Office Action Summary

10/539,189

CORBETT ET AL.

DETAILED ACTION

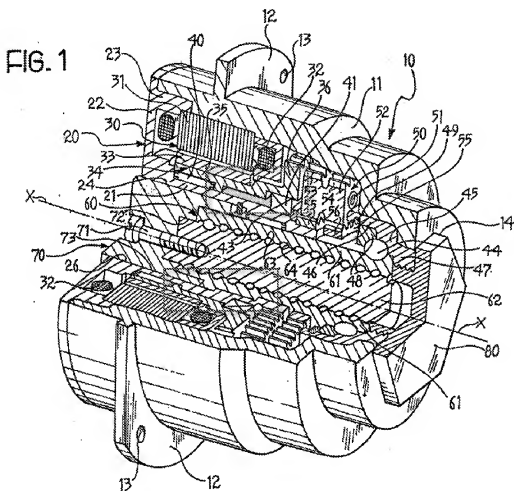
5. The drawings are objected to as failing to comply with 37 CFR 1.84(p)(4) because in figure 1, reference characters (55) and (56) both point to what is described as the output gear (56) in the specification (page 4, first paragraph). Reference character (55) is also used to refer to a fixed gear. It is proposed that applicant not point reference character (55) at the output gear in figure 1.

6. The drawings are objected to under 37 CFR 1.83(a). The drawings must show every feature of the invention specified in the claims. It is claimed in claim 1 that supporting element (21) externally, rotatably supports the rotor (34) of the electric motor (30). Figure 1 demonstrates an asymmetric approximation of this. The upper cross-section is not congruent to the bottom cross-section in many respects, and delineates a

space (shaded area), whereas the bottom does not.

Therefore, it is recommended that applicant at least correct Figure 3 and perhaps the lower cross-section of Figure 1, or else at least make reference in the specification to the most accurate rendition of the claimed subject matter, or cancel the features from the claim(s). No new matter should be entered.

FIG. 3

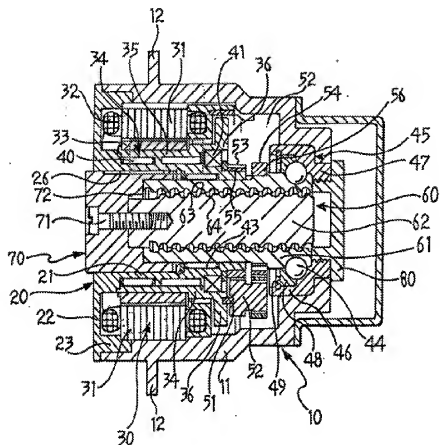
7. Figure 3 shows a symmetric rendition of the relationship between the supporting element and the rotor, but does not delineate a separating line between the two elements, suggesting to an observer that they may rotate as one element.

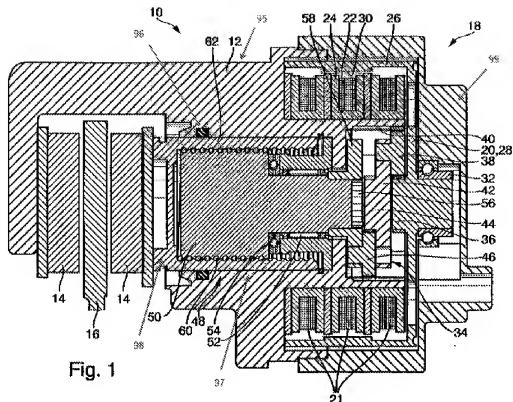
21. As to claim 1, Hilzinger '552 discloses an electro-mechanical screw actuator assembly (electromechanical wheel brake device 10), of the type comprising:

- a housing (99), fixable to a motor vehicle,

- an electric motor (18) mounted within the housing (99) and comprising a stator (yokes 24 in combination with excitation device 22, see paragraph 15) fixed to the housing (99) and a rotor (20),

- a screw mechanism (ball screw 48, see claim 7), including a rotatable nut (62) and a central screw (spindle 50) translatable along a given axis (x),

- gear reduction means (reduction gear 34 in combination with a planetary carrier 58) disposed between the rotor (20) and the screw mechanism (48) for provoking a translation of the screw (50),

- wherein the housing (99) is secured to or integral with a supporting element (brake caliper 12) of essentially tubular cylindrical shape extending within the housing (99) coaxial to said axis (x), and wherein the supporting element (12)

- externally, rotatably supports the rotor (20) of the electric motor (18)
 - internally, rotatably supports the nut (62) of the screw mechanism (48);
 - wherein the supporting member (12) supports externally at least one fixed gear (planet carrier 58) of the gear reduction means (reduction gear 34 in combination with a planetary carrier 58).

U.S. Patent
 Aug. 3, 1999
 Sheet 3 of 7
 5,931,268

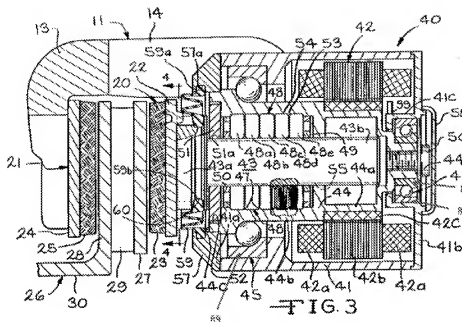
31. As to claim 8, Hilzinger '552 discloses the actuator assembly according to claim 1, and a screw mechanism (48) but the screw mechanism is not supported at an end thereof by an angular contact ball bearing. Kingston '268 discloses a screw mechanism (spindle 43 inside an output shaft 44 in combination with planetary rollers 48) rotatably supported at an end thereof by an angular contact ball bearing (45).

32. As to claim 9, Kingston also discloses the radially outer raceway of the angular contact ball bearing (45) formed at least partially by a sleeve member (89) axially locked onto housing (41).
